From: Julie Grieves on behalf of Planning.Responses
Sent: 05 April 2019 10:18
To: Planning Scanning
Subject: FW: Planning Consultation on BN/14/19/DOC
Attachments: 'the Cottage Piggeries' 2014-SK2 Surface Water Drainage Layout.pdf

Engineers Comments Regarding Condition 3- Surface Water Drainage Design

Registered: 29-MAR-19
Site Address: The Cottage Piggeries Church Lane Barnham PO22 0DB
Description of Works: Approval of details reserved by condition imposed under ref BN/19/18/PL relating to Condition No 3 surface water drainage.

Client
Albert Brazil
Drawing Title
Surface Water Drainage

© This drawing is copyright It may not be copied or reproduced without written authority			
Scale	As shown	At original	A3
Drawing Number	2014/SK2		Revision -

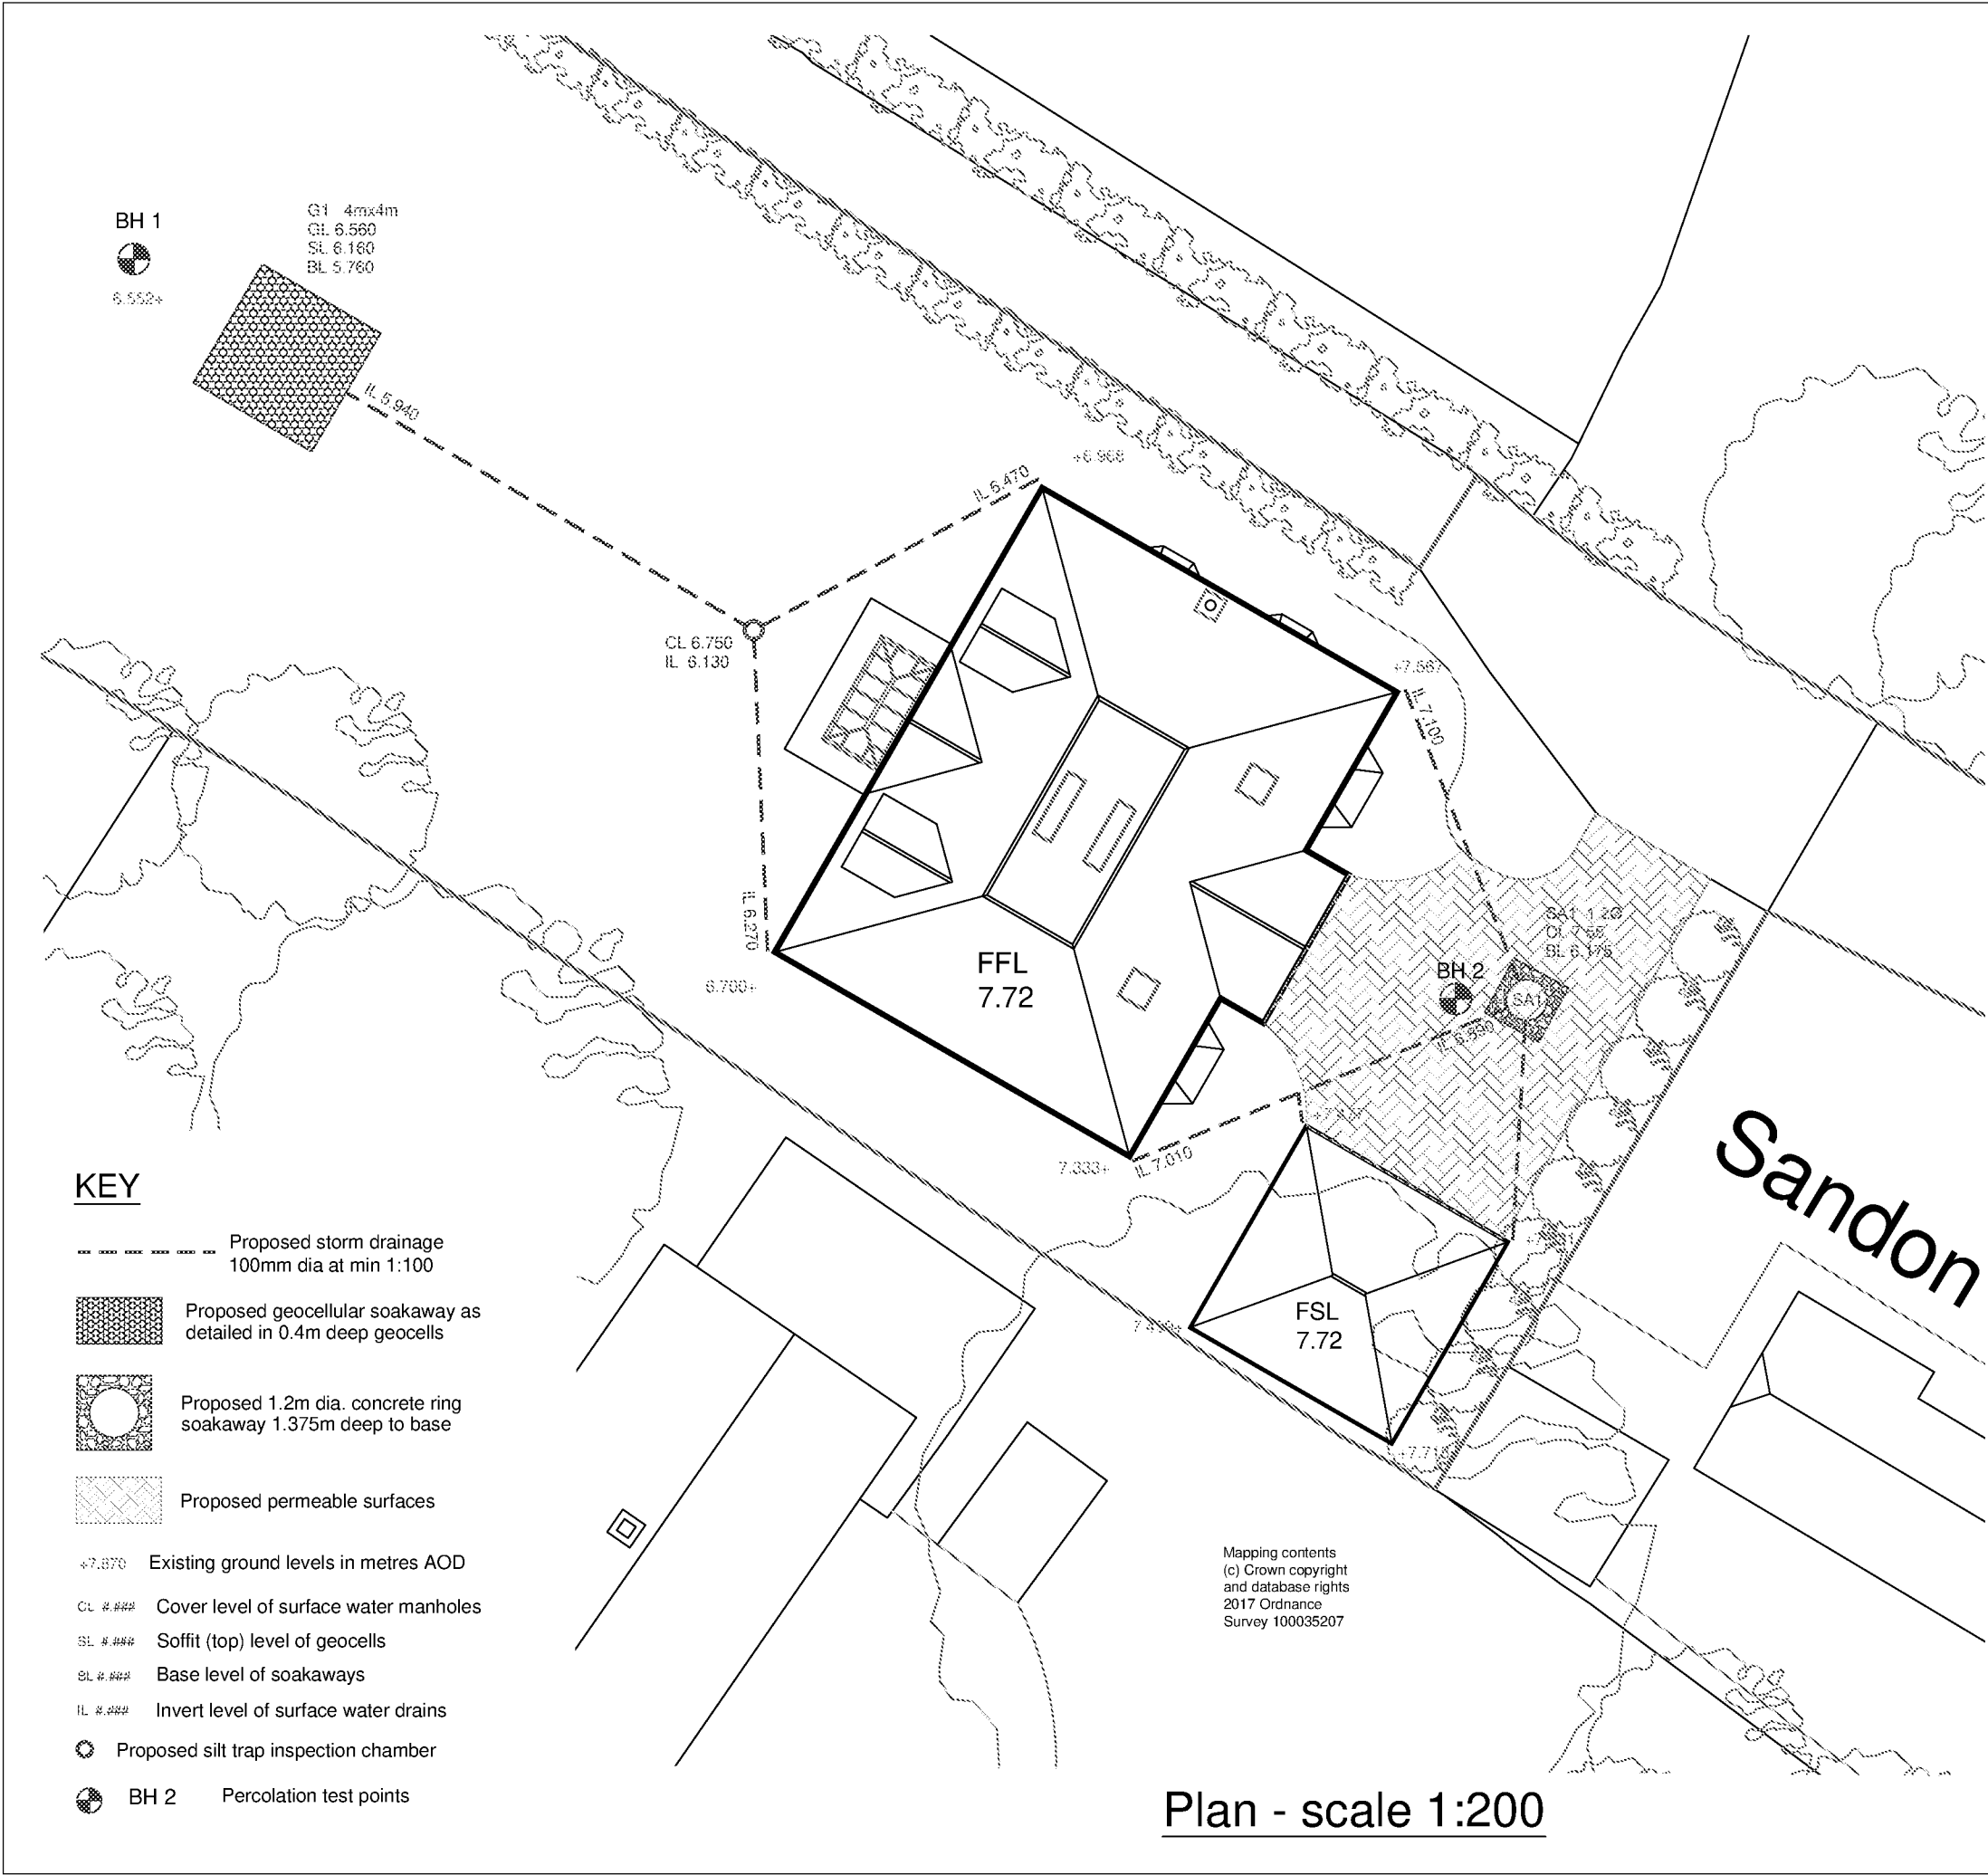
Winter groundwater monitoring and infiltration testing has been completed. The highest groundwater levels encountered were at 0.79m depth. It is unclear at which of the three monitoring locations that this peak occurred. Please can this be confirmed.

The soakaway that is proposed to be located in the rear garden has an invert level of 5.66m (0.9m below ground). The base of this soakaway must be located above the maximum recorded groundwater level, or adequate volume must be provided above the groundwater level.

I have received a revised layout from the client's engineer (attached). The base of the soakaway has been raised so that sufficient capacity is available above groundwater, and the layout now matches the calculations. Based on this revised drawing, and the previously submitted calculations and details I am happy to recommend the discharge of condition 3.
